Doran Drive Plaza Precinct

State Significant Development Assessment
SSD-15882721

July 2022

Published by the NSW Department of Planning and Environment

Figure 19 | Connections through the retail area (Source: RtS)

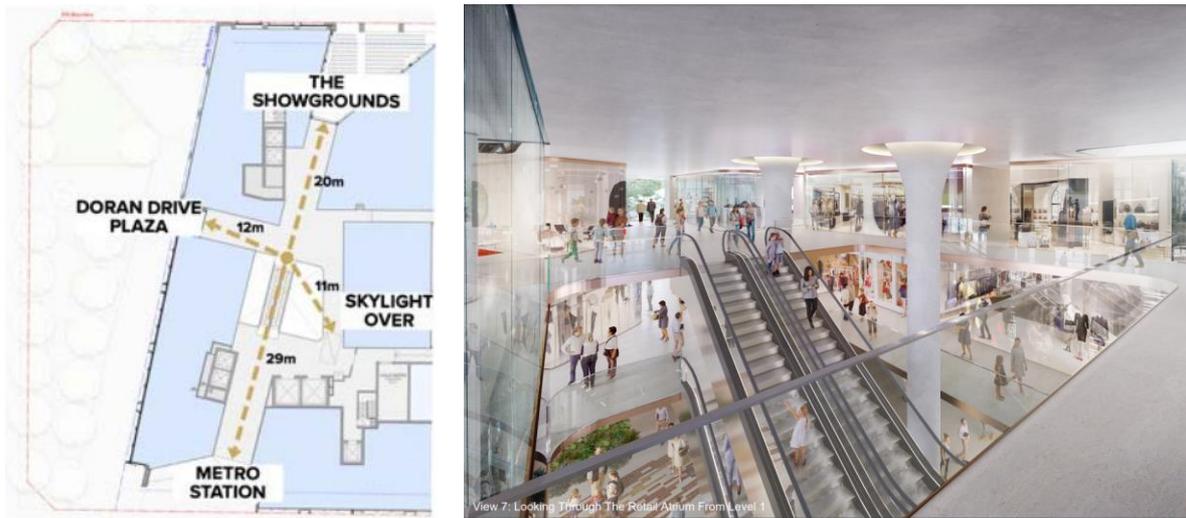
78. The SDRP raised concerns the proposal does not present a permeable ground plane with active edges to support its function as the 'active heart' of the Precinct. The SDRP also noted the pedestrian entry directly opposite the Metro station should promote movement through the site. The SDRP suggested opportunities should be explored to introduce natural light, more generous proportions, and a more direct route through the site.

81. In response to SDRP advice, the Applicant also amended the proposal to allow for more natural light and visual connections between the retail area and the street frontages. The amended

proposal also added substantial glazing and a skylight within the podium to increase natural light and improve permeability and visual connections through the site.

82. The Department considers the proposed podium provides an appropriate scale to the street as it presents a series of smaller scale buildings ranging in height from two to four storeys and it incorporates both vertical and horizontal articulation to break up its mass. The Department also supports the variation in materiality and architectural design used along the different street frontages as it provides an appropriate transition between the active retail frontages from Doran Drive to the residential character towards Precinct East along Andalusian Way.

Figure 20 | Vehicular access points (Source: RtS)

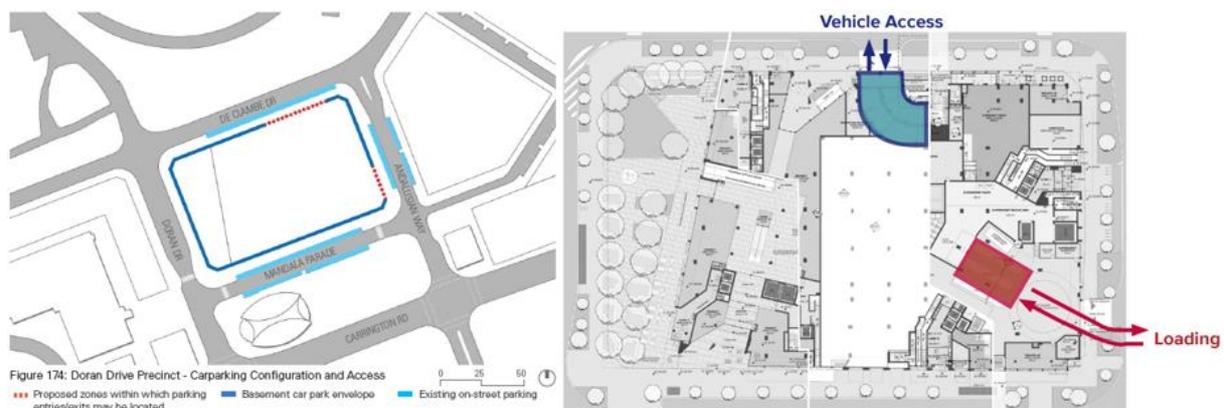
86. Council raised concern that the location of the vehicular access along De Clambe Drive would reduce opportunities for landscaping and activation of the northern street frontage. Council argued that the proposal is inconsistent with the desired future character of the Hills Showground Station Precinct, which envisaged an active street frontage and a more sensitive interface to the Castle Hill Showground.

88. In response, the Applicant argued the retail levels of the podium have been designed to push the services, loading dock, and back of house areas, into the middle of the floorplate, allowing for fine grain retail and other active uses around the perimeter of the development.

89. The Department also considers the number and width of vehicular access to site have been minimised relative to the length of the street frontages of the site. The Department notes the accesses and services are well integrated into the amended podium façade and would not detract from the streetscape (**Figure 21**).

Figure 22 | Approved street and tower setbacks (Source: Concept Approval)

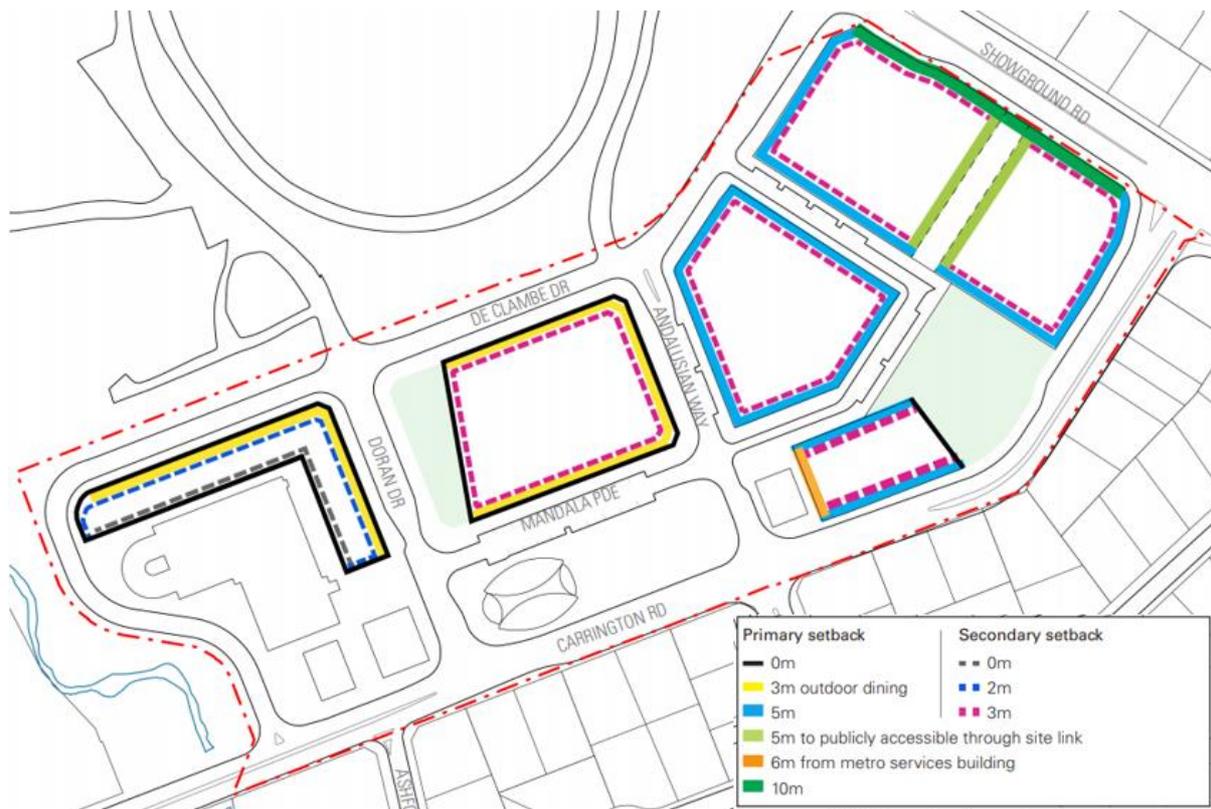
- 93. The proposal seeks approval for nil street setbacks and 3 m tower setbacks, consistent with the setback controls within the UDG.
- 94. Council raised concern about the proposed setbacks as they would depart from the setbacks set out in the Hills DCP, which require a 3 m street setback to De Clambe Drive and a 5 m tower setback for all towers above the podium (see **Figure 23**).

- 95. In response, the Applicant advised the Hills DCP does not apply to SSD applications. The Applicant also advised that the proposal complies with the setbacks prescribed by the UDG and as such would result in an acceptable urban design outcome.
- 96. During the assessment of the Concept Approval, the Department considered the objectives of Council's DCP street setback controls which are to provide a strong definition between public and private domain, create consistent streetscapes, accommodate landscaping, and facilitate

97. The Concept Approval permits a nil setback along De Clambe Drive as it would provide an active street frontage, as well as a Plaza fronting Doran Drive. The Concept Approval adopted a 3 m tower setback to balance the need to mitigate the visual bulk of the tower buildings and to allow sufficient building separation between the towers, which is limited by the lot depth.

- the nil street setbacks are consistent with other active street frontages within the approved Hills Showground Precinct (see **Figure 22**)
 - additional recesses or colonnades are integrated within the building (along De Clambe Drive, Andalusian Way and Mandala Parade) to accommodate outdoor dining and ensure pedestrian movement and street tree planting would not be compromised

Figure 26 | Building separation across podium communal open space (above) and visual privacy between internal elevations of Building A and Building B (below left) and between Building C and D (below right) (Source: RtS)

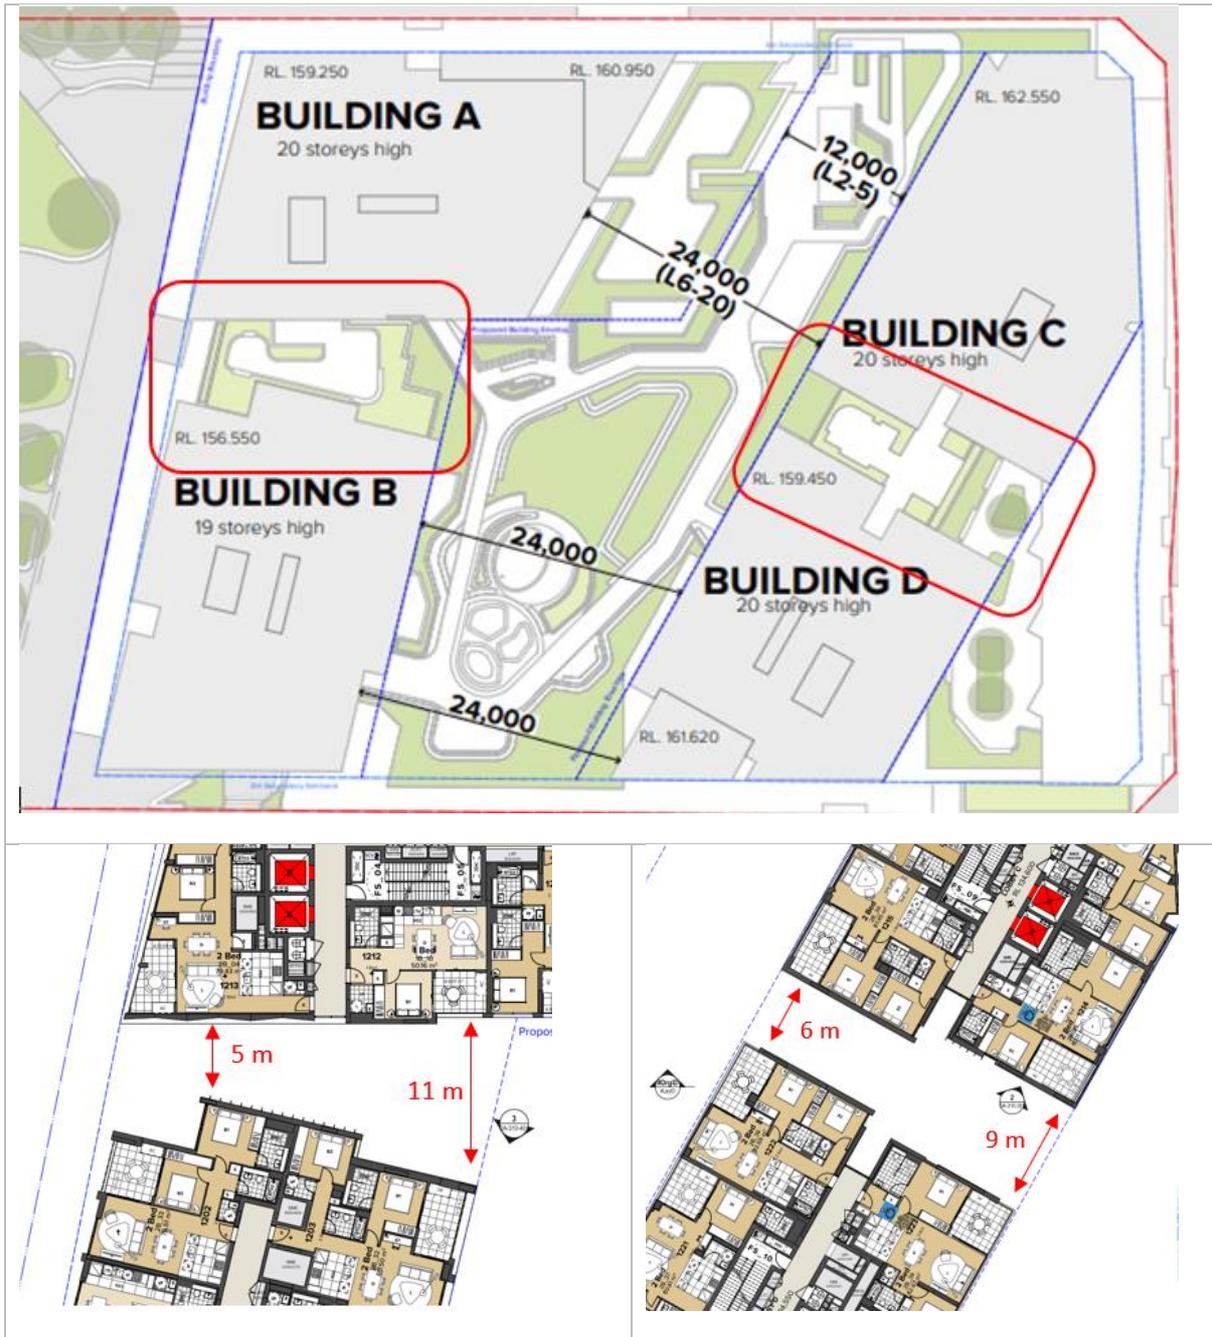
115. The ADG requires a minimum 24 m separation distance (for 9 storeys above) between habitable rooms but it allows for a reduction to 18 m between habitable and non-habitable rooms and 12 m between non-habitable rooms, reflecting the key objective of the required building separation distance is to maintain privacy between developments.

116. The Department notes the proposed buildings have a 24 m building separation across the communal open space above the podium in accordance with the ADG requirements. However, the proposed building separation is less than 12 m between the internal elevations of Buildings A and B and Buildings C and D (**Figure 26**).
117. The Department notes the ADG requirements generally apply to rooms that are facing each other and do not specifically relate to separation between blank walls or for rooms facing blank walls.
118. The Department has carefully considered the amenity and privacy outcomes of the proposed dwellings and is satisfied the proposed building separation is acceptable in this case because:

Figure 32 | Projected traffic volumes during peak hour (source: VARGA Traffic Planning, 2022)

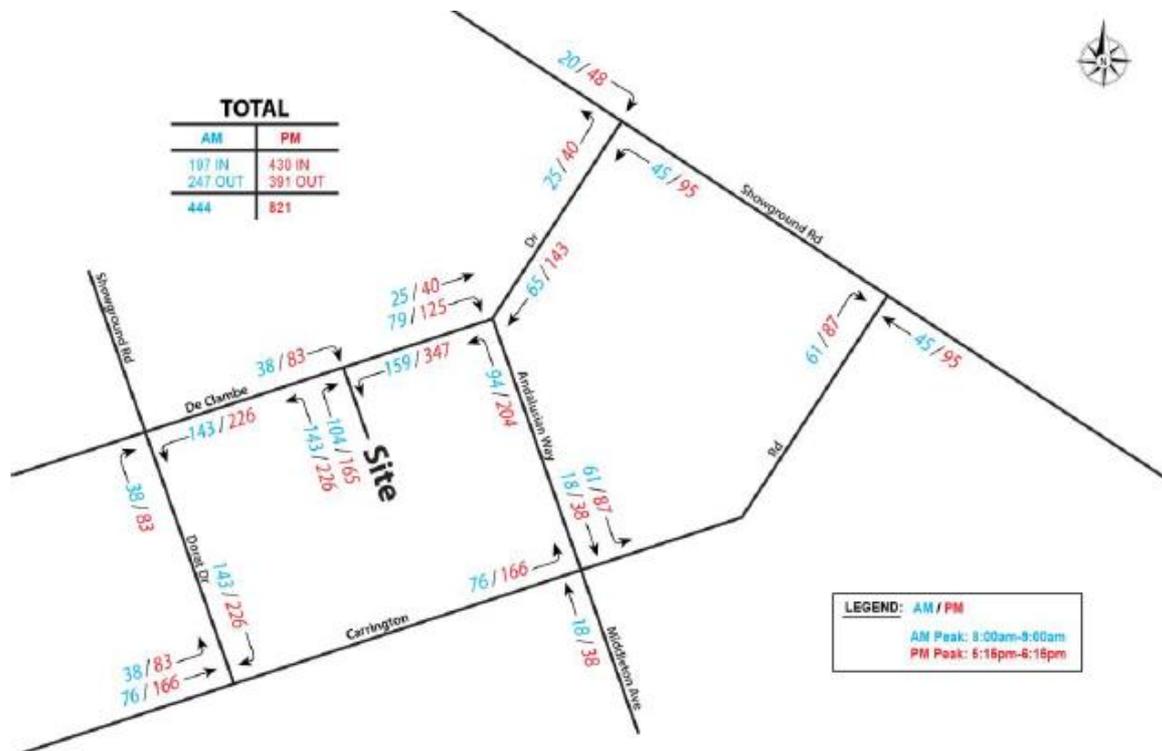
161. The proposal is accompanied by a Traffic and Parking Assessment (TPA) which identified the proposal would generate 444 vehicles per hour during the AM peak and 821 vehicles per hour during the PM peak. The distribution of volumes onto the surrounding road networks is shown in **Figure 32**.

162. Council raised no objections to the traffic impacts and noted that the predicted traffic generation is consistent with the Applicant's Traffic and Transport Assessment (TTA) submitted with the Concept Approval (SSD-9653). However, Council raised concern about potential traffic queuing at De Clambe Drive due to a right hand turn into the development and the safety of swept turning paths for 12.5m HRV into the loading dock. Council recommends a median island be provided to restrict right turn movements should a queue occur on De Clambe drive or in the proposed car park.
